Subject: East Altamont Energy Center Application for Certification
Data Request Response Set #1 (01-AFC-04)

East Altamont Energy Center
Data Requests and Responses (01-AFC-4)
Set #1

EAST ALTAMONT ENERGY CENTER DATA REQUEST AND RESPONSE SET #1 (01-AFC-4)

Technical Area: Visual Resources

Figure 7.2e

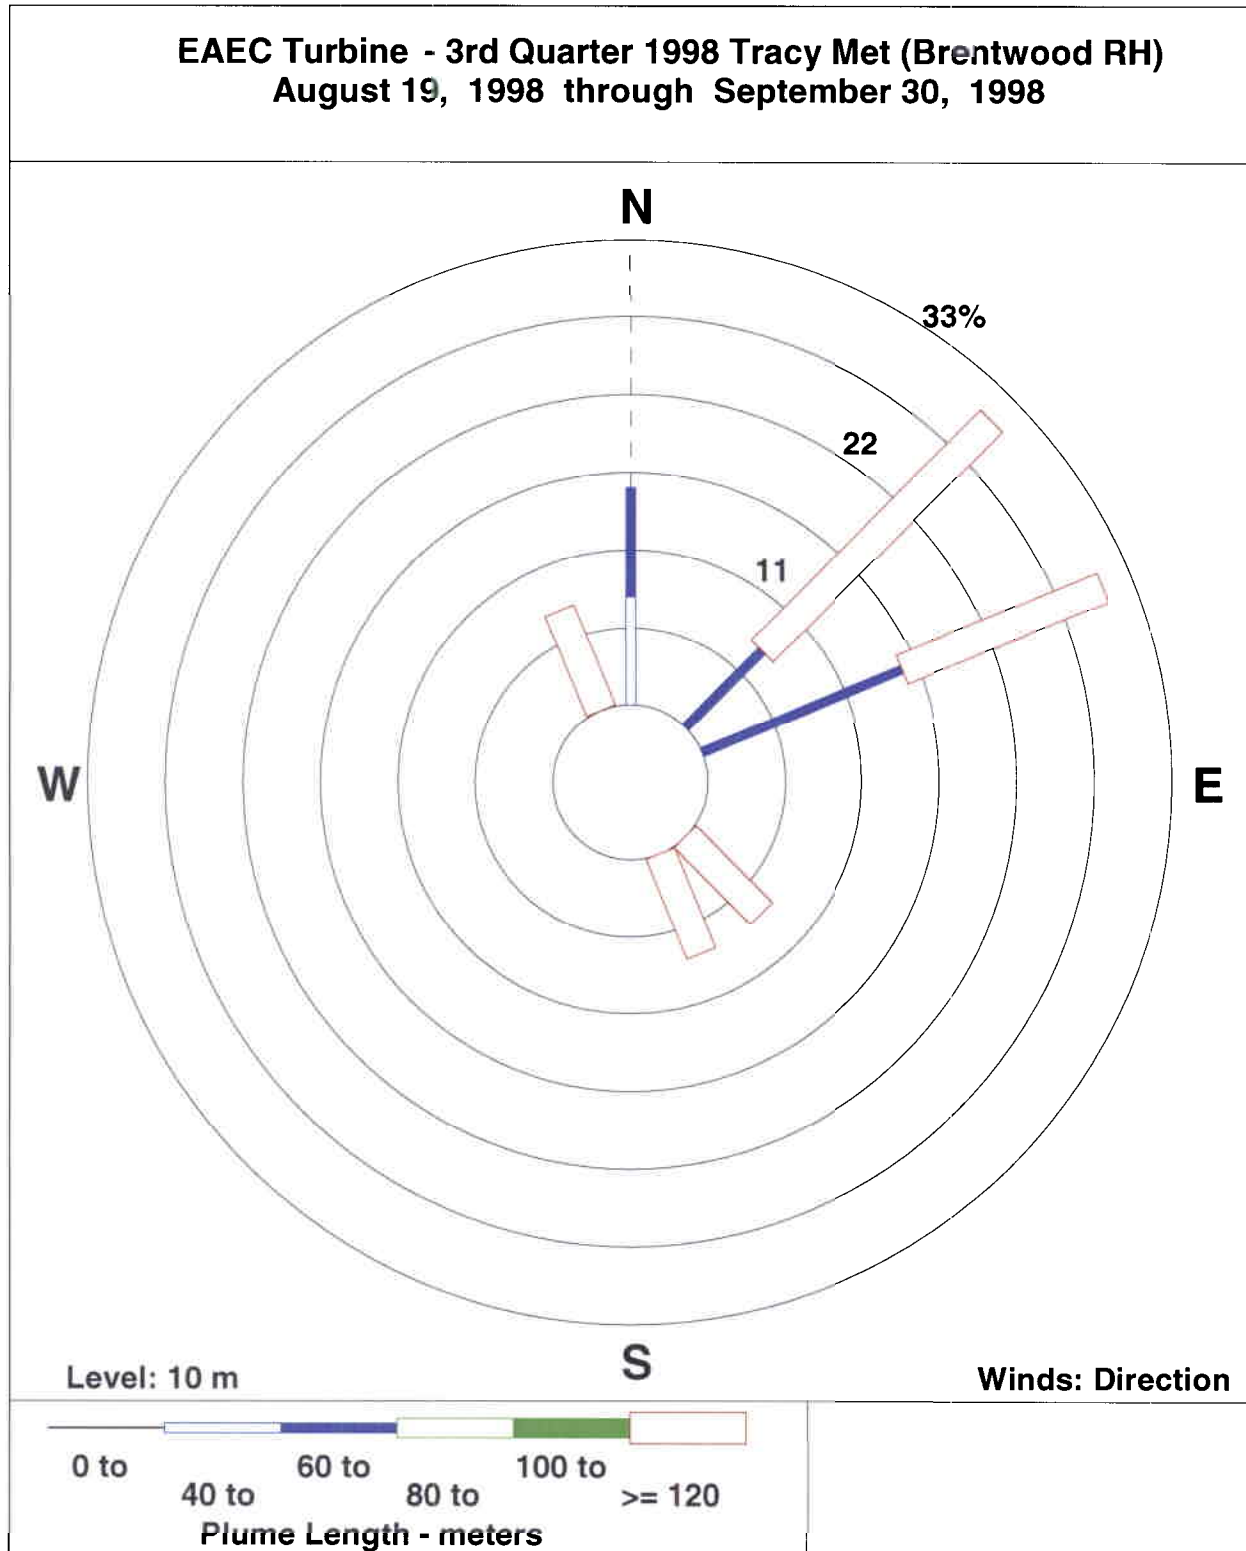
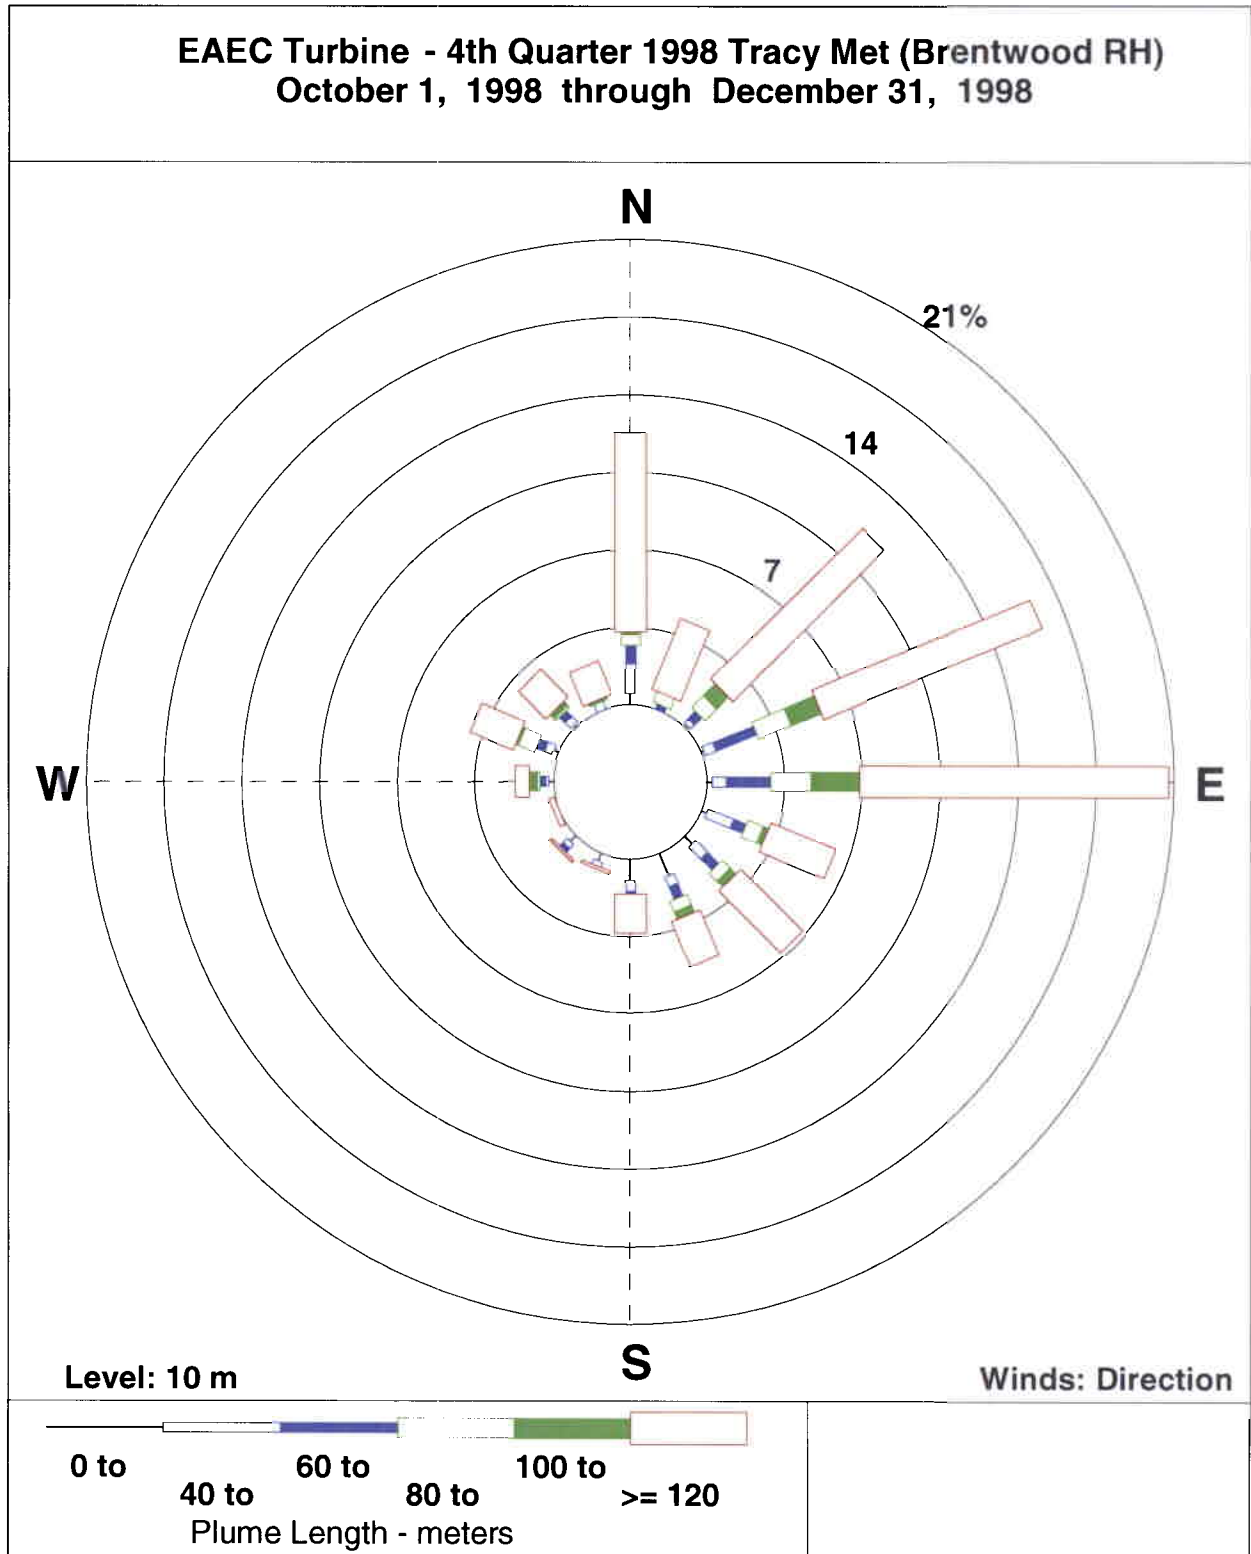
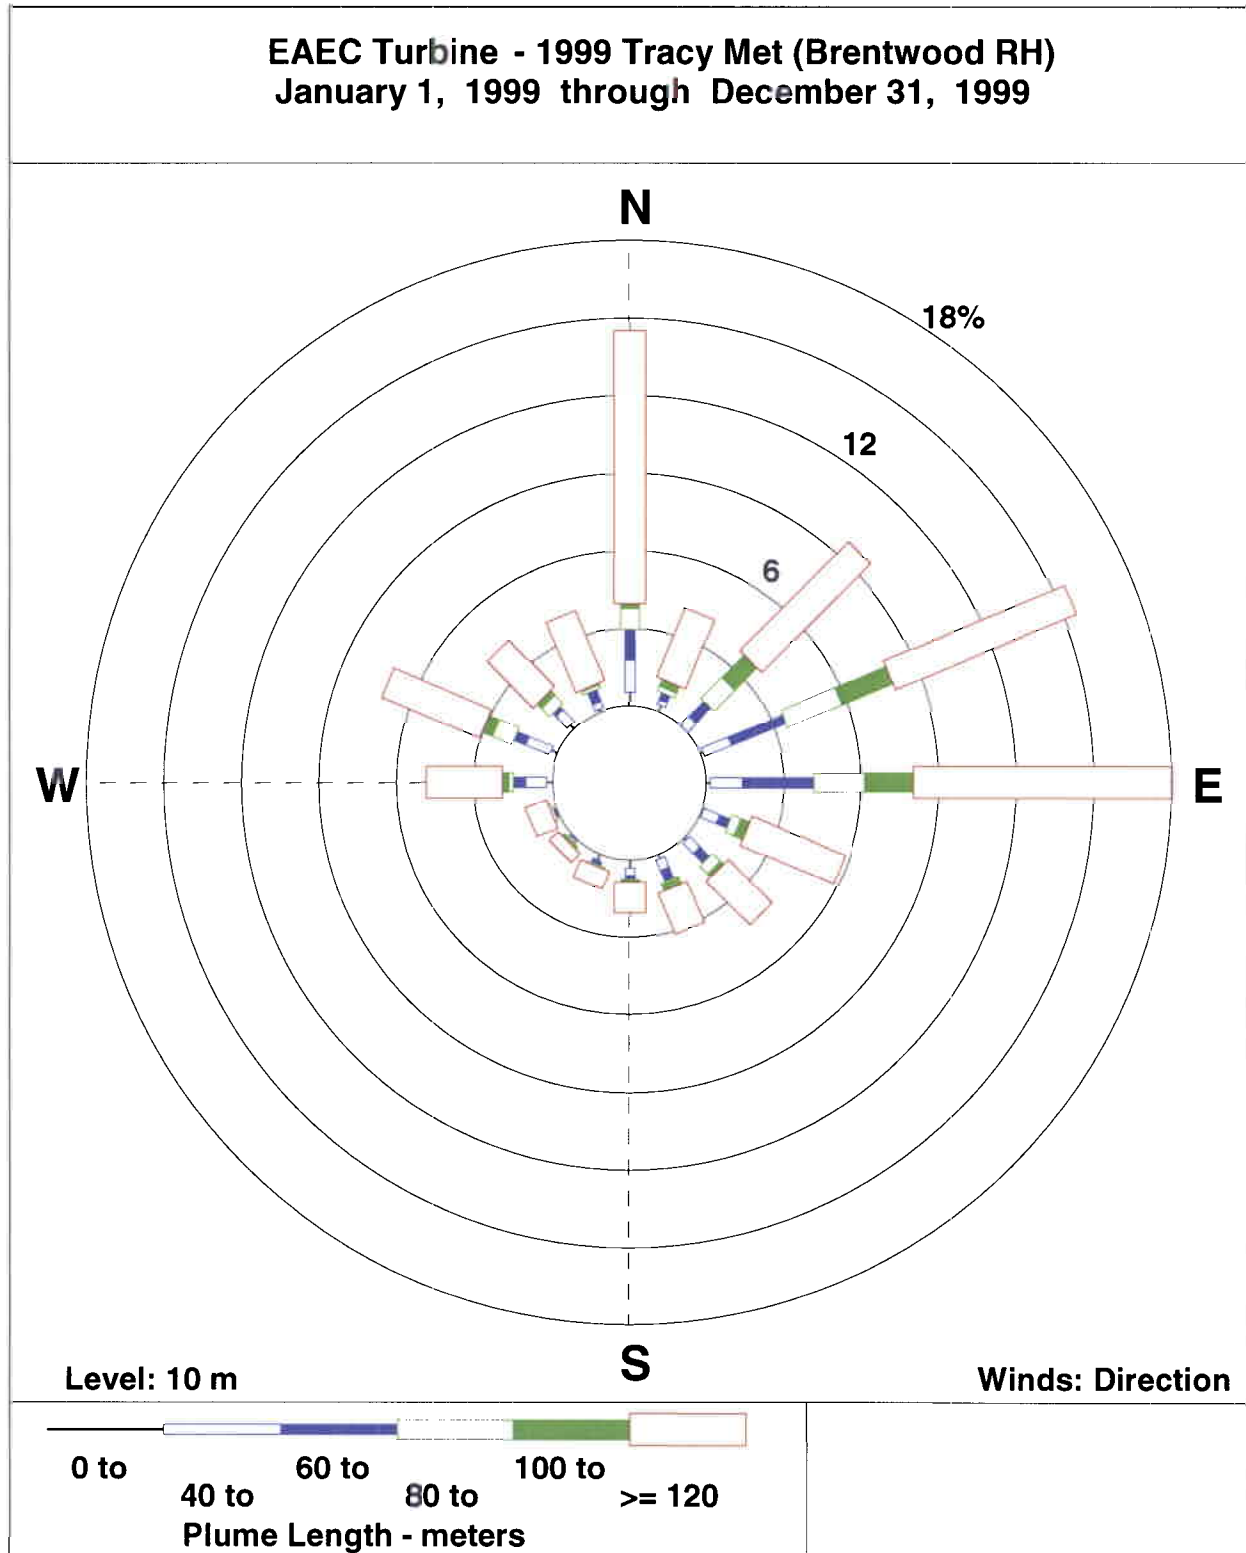
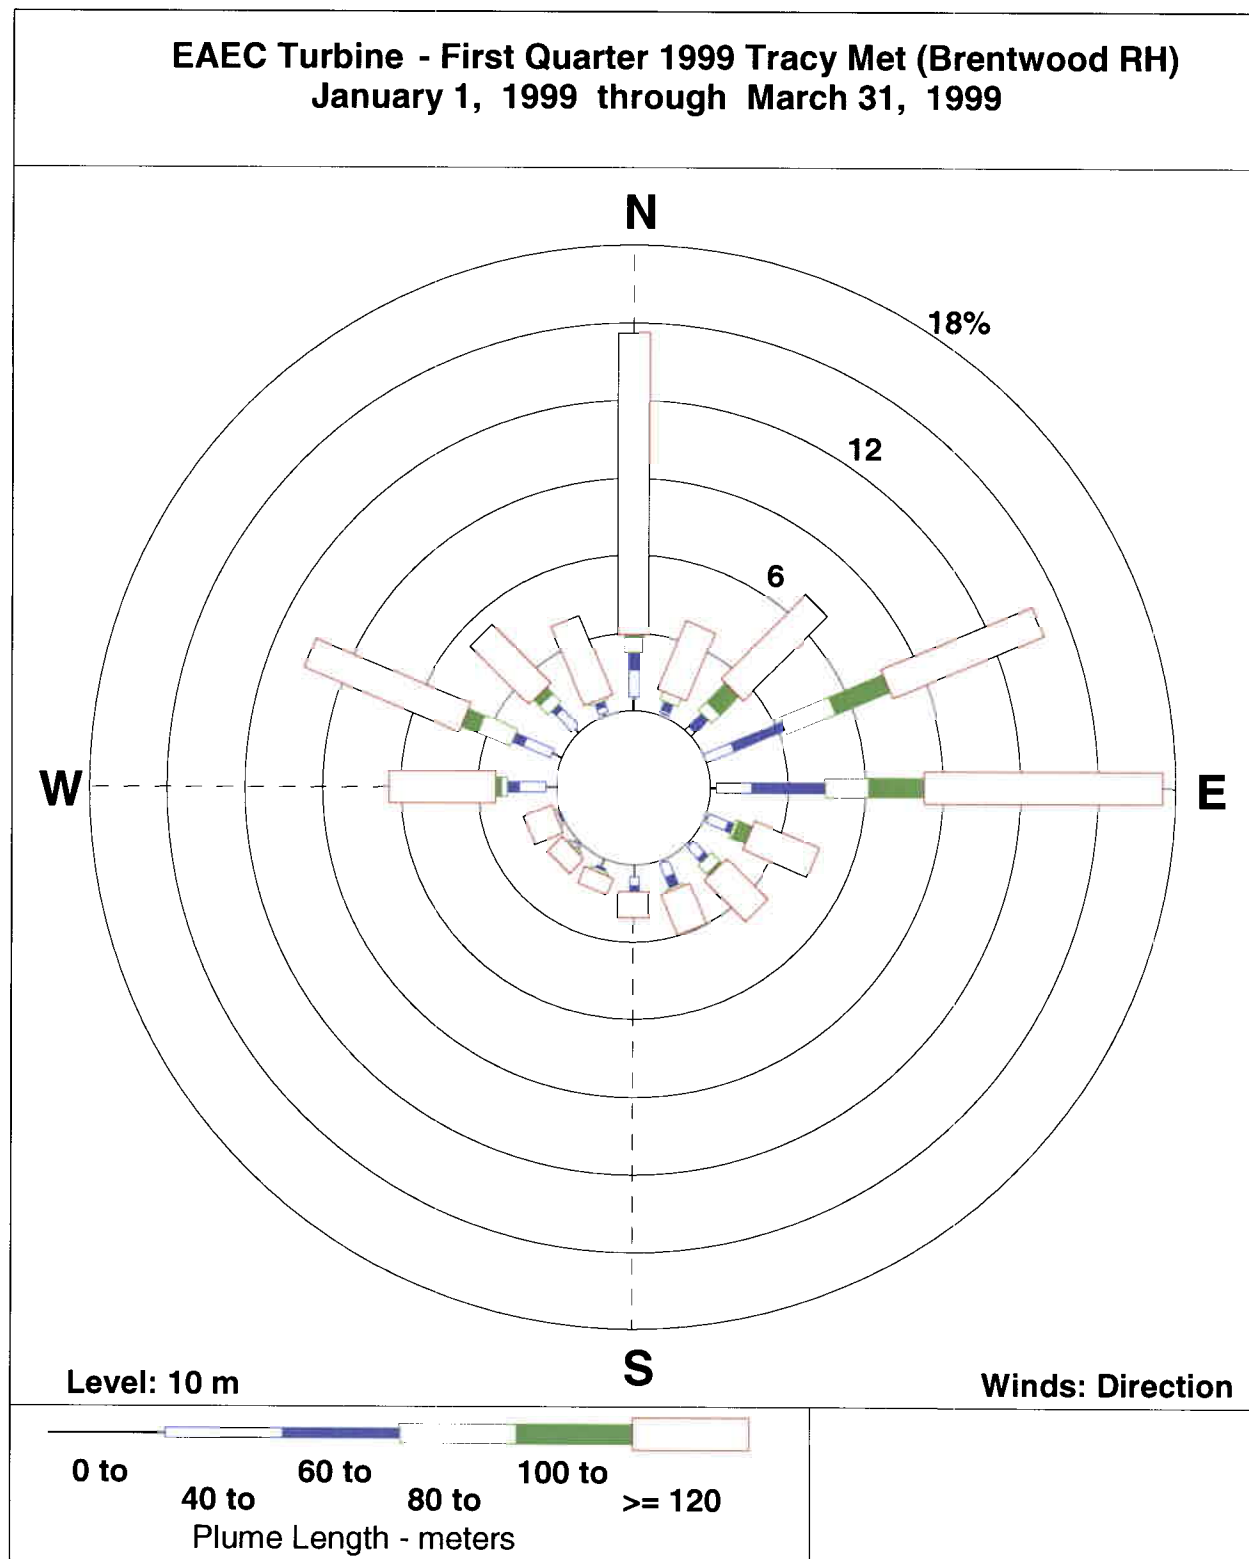
- a. The total number of daylight hours annually and seasonally;

Response: Table VIS-7.1 shows the number of hours per year that there is the potential for formation of a visible water vapor plume of various lengths from each HRSG stack. The analysis assumes that each HRSG is operated for 8,760 hours per year. During the hours between 6 a.m. and 8 p.m., the units are assumed to operate at full load with duct firing and power steam augmentation; during all other hours, the units are assumed to operate at full load, but without duct firing or power steam augmentation. The analysis was performed for each of the three years of meteorological data available.

A seasonal distribution of these hours is presented in the plume roses included as Figures VIS-7.1a through VIS-7.3e.
